CHAPTER 3

Comments and Responses

3.1 Comments on the Draft EIR and Responses

This section contains all comment letters and responses to comments. Each comment letter is assigned an alphanumeric code, from A1 through C40, and each comment is numbered in the margin of the comment letter. Responses to the comments follow each letter, and responses are referenced using the same alphanumeric system. For example, the first comment from the first letter, from the National Oceanic and Atmospheric Administration, is designated A1-1, as is the response to it. Testimony from the public hearing is assigned the code “PH” and follows the comment letters.

Figure 3-13a
Water Surface Elevation Change With Project
10 - Year Flood Event: Fairfax Area

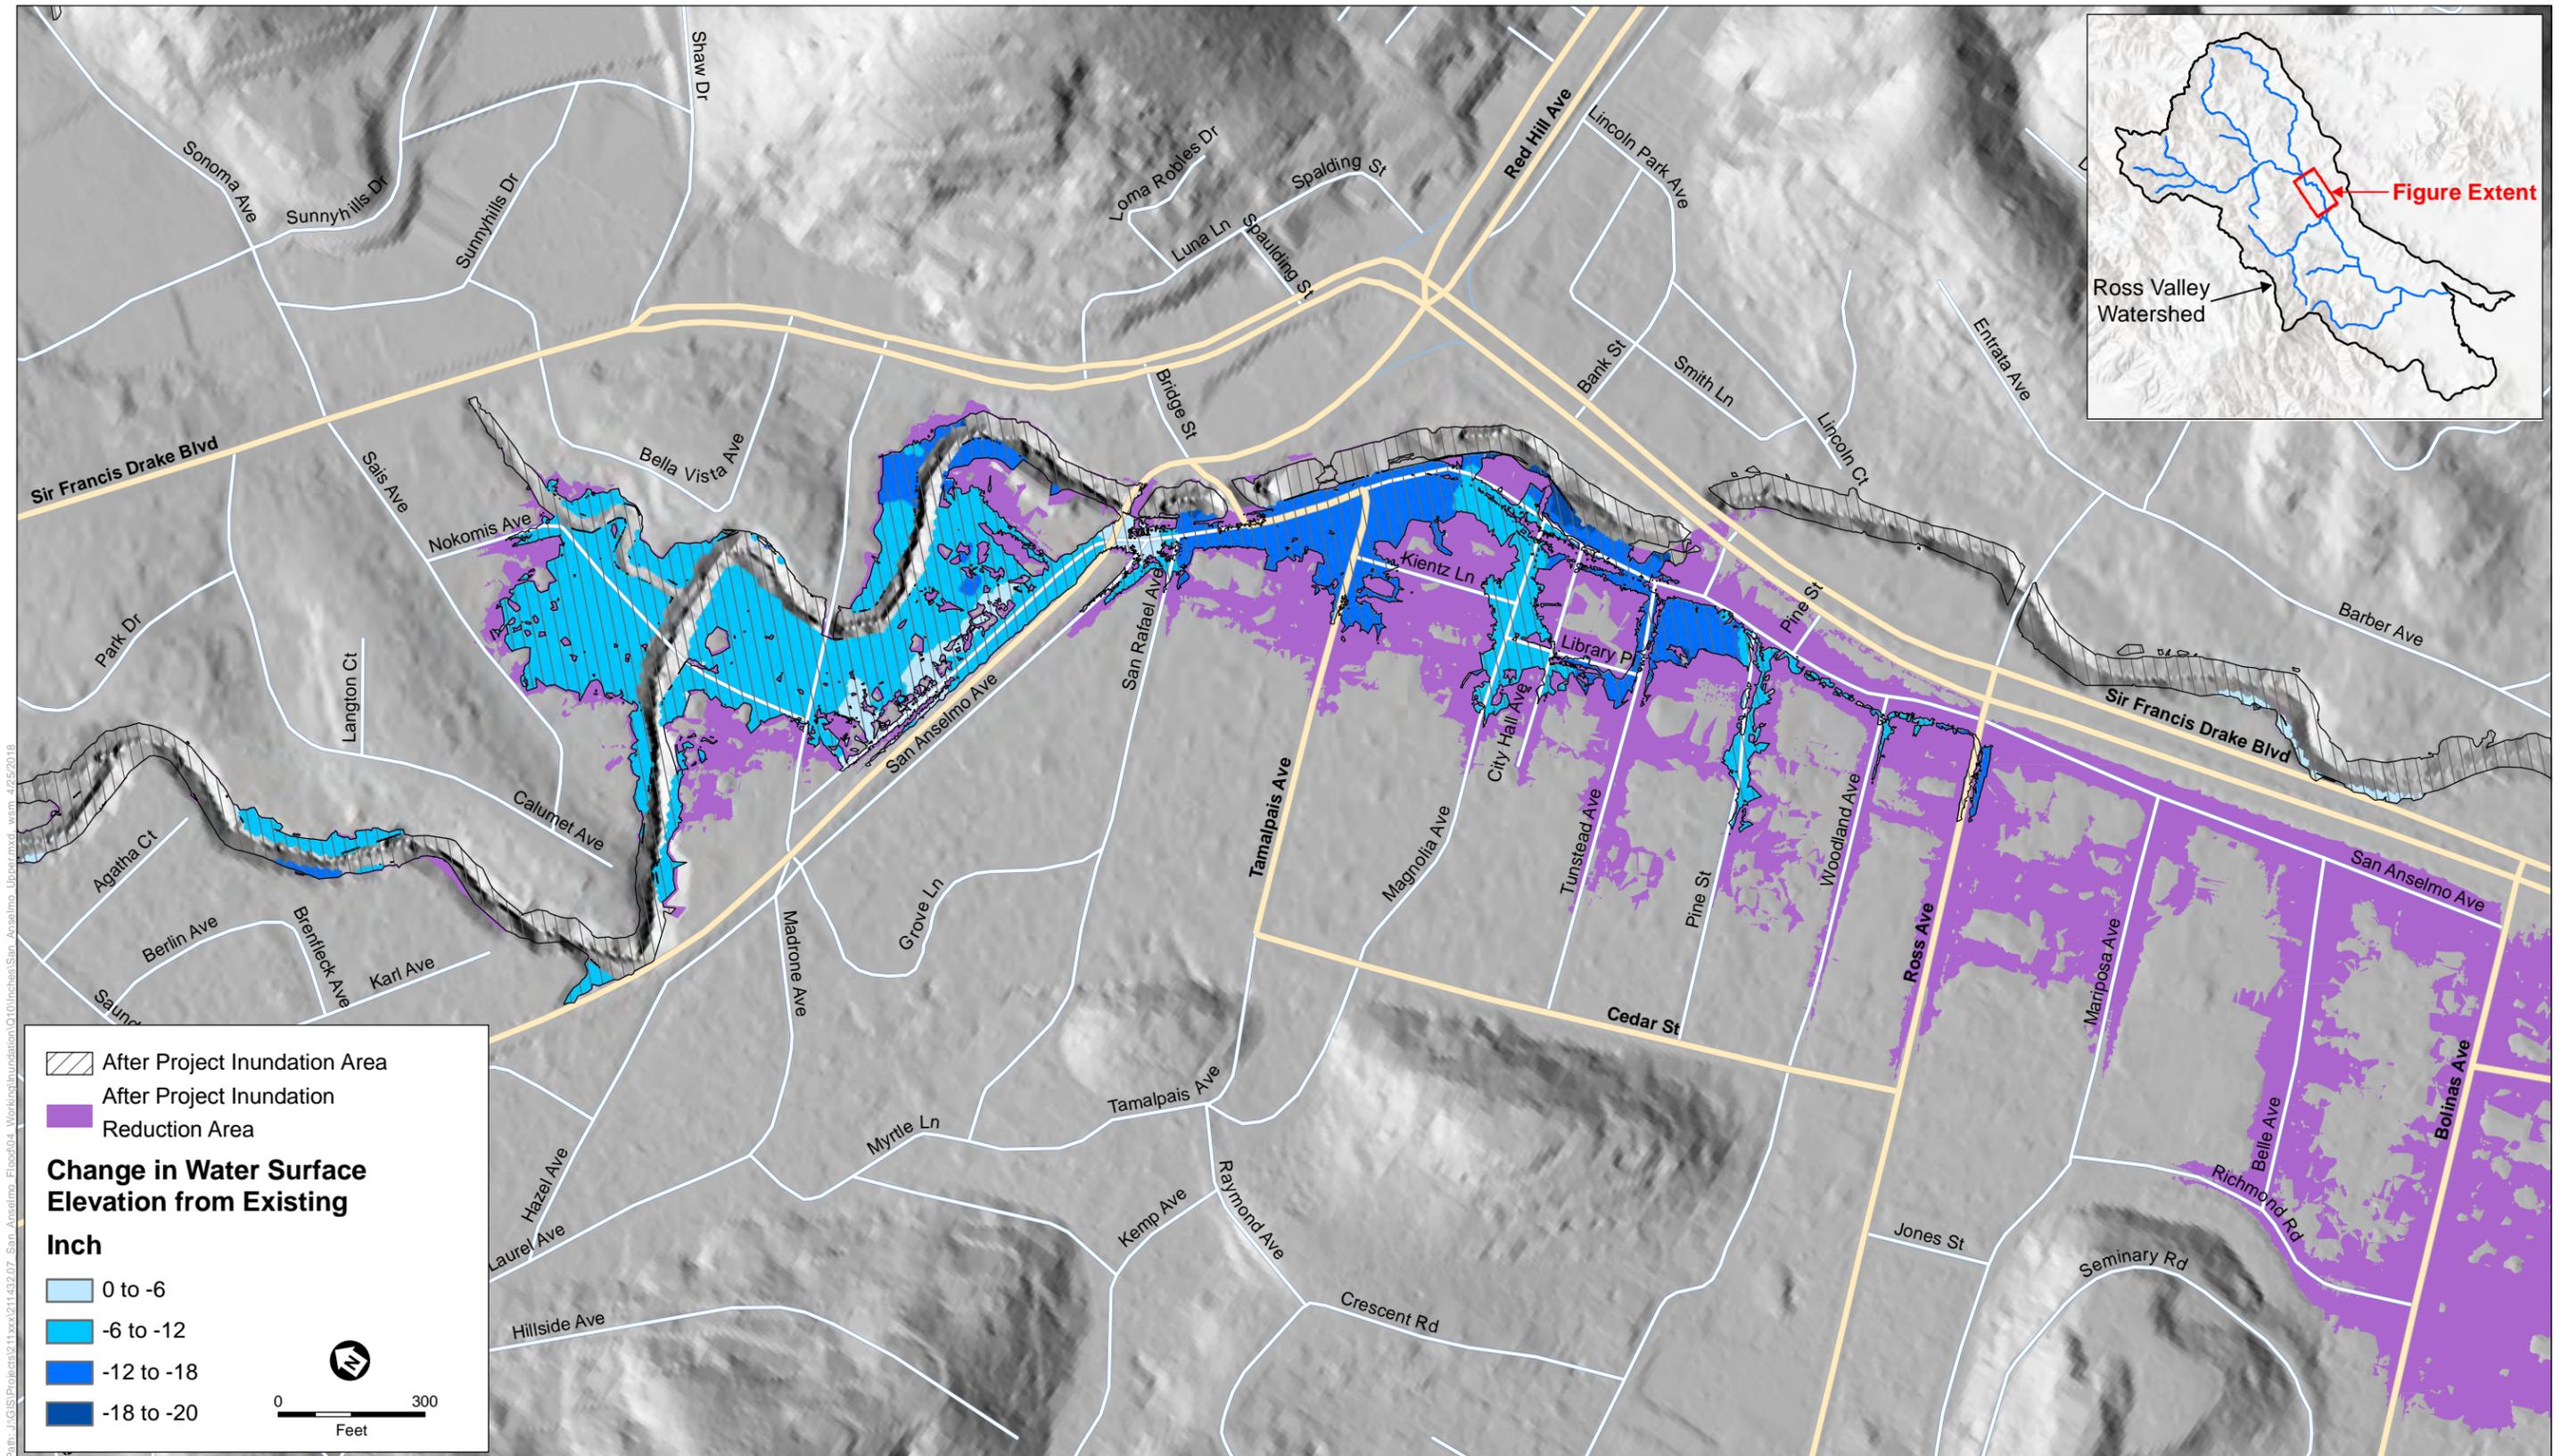
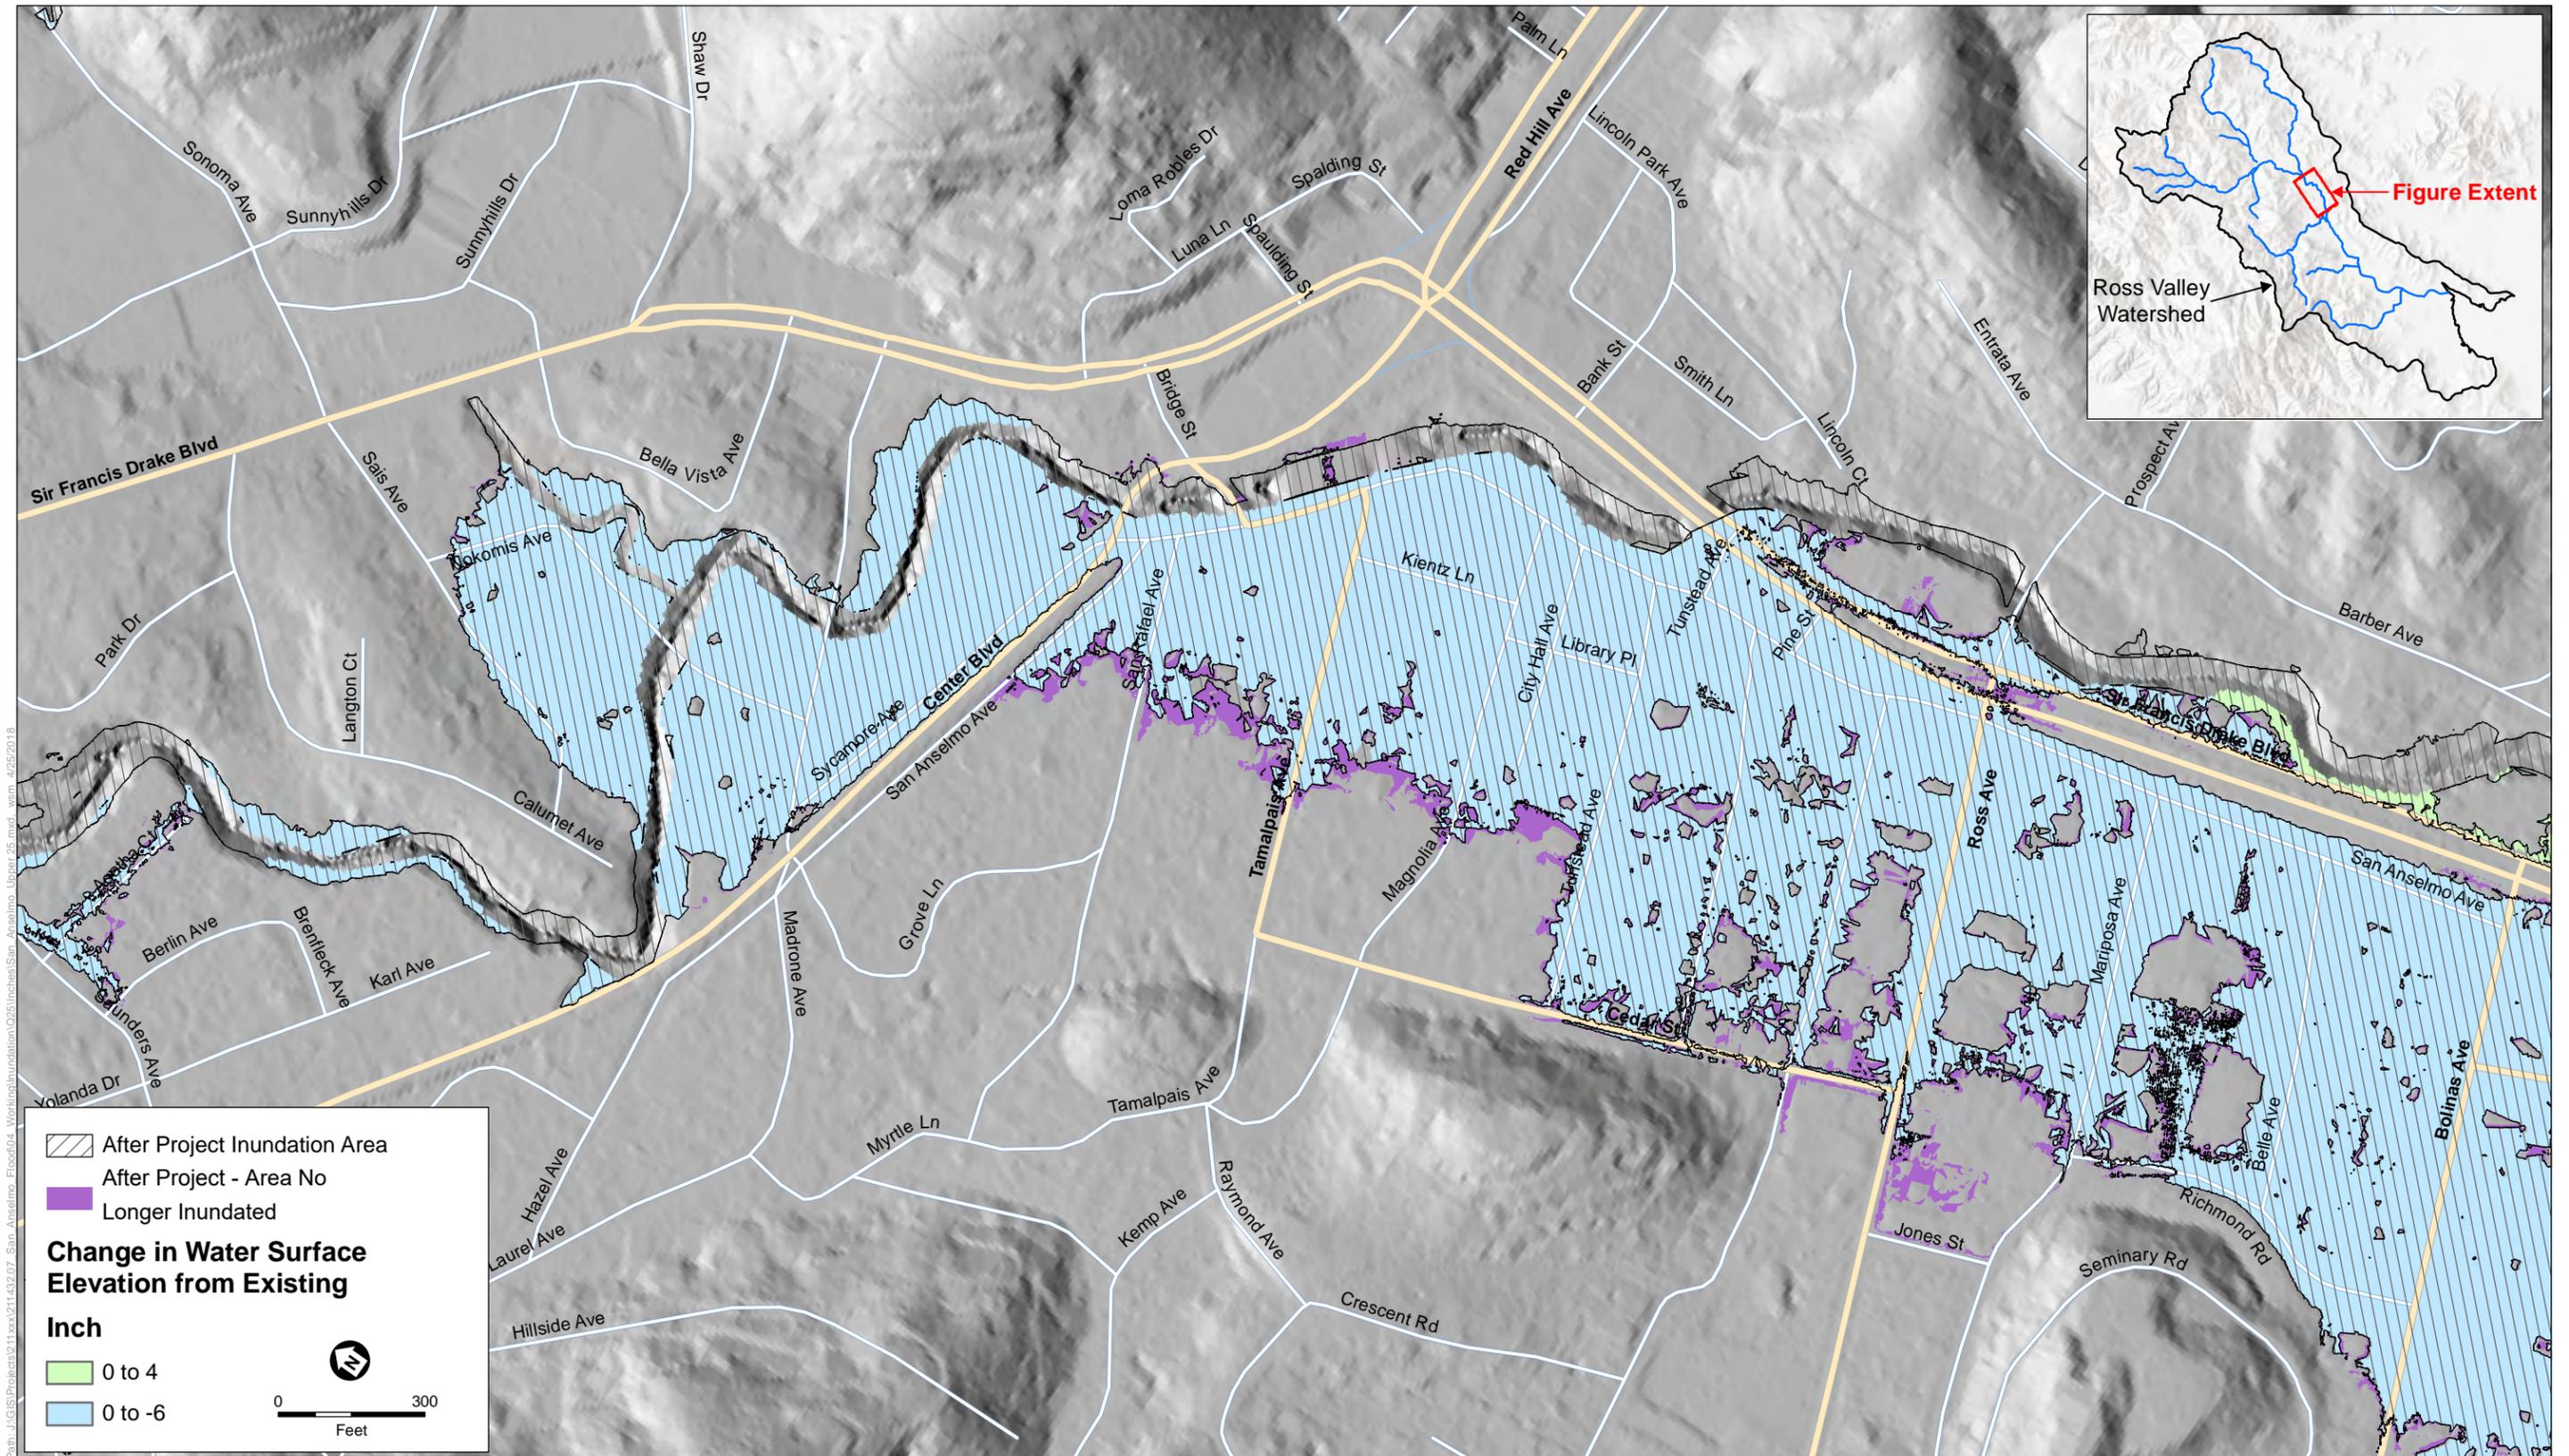
Figures in Chapter 3 (figures 3-13, 3-14, and 3-15), that show water surface elevation, change with project are not easy to interpret. It appears that the purple areas, labeled "After Project Inundation Reduction Area" would be removed from flooded areas during the specified events. However, use of the word "reduction" suggests that they would still be inundated, just to a lesser extent.

Draft EIR Figures 3-13a-c, 3-14a-c, and 3-15a-c have been revised in response to this comment. The revisions to these figures do not result in any changes to the environmental analysis in the Draft EIR.

In response to Comments B1-5 and PH-2, the legend descriptions associated with purple areas of Draft EIR Figures 3-13a-c, 3-14a-c, and 3-15a-c (Draft EIR pages 3-25 through 3-33) have been revised to read:

After Project ~~Inundation Reduction Area~~ – Area No Longer Inundated
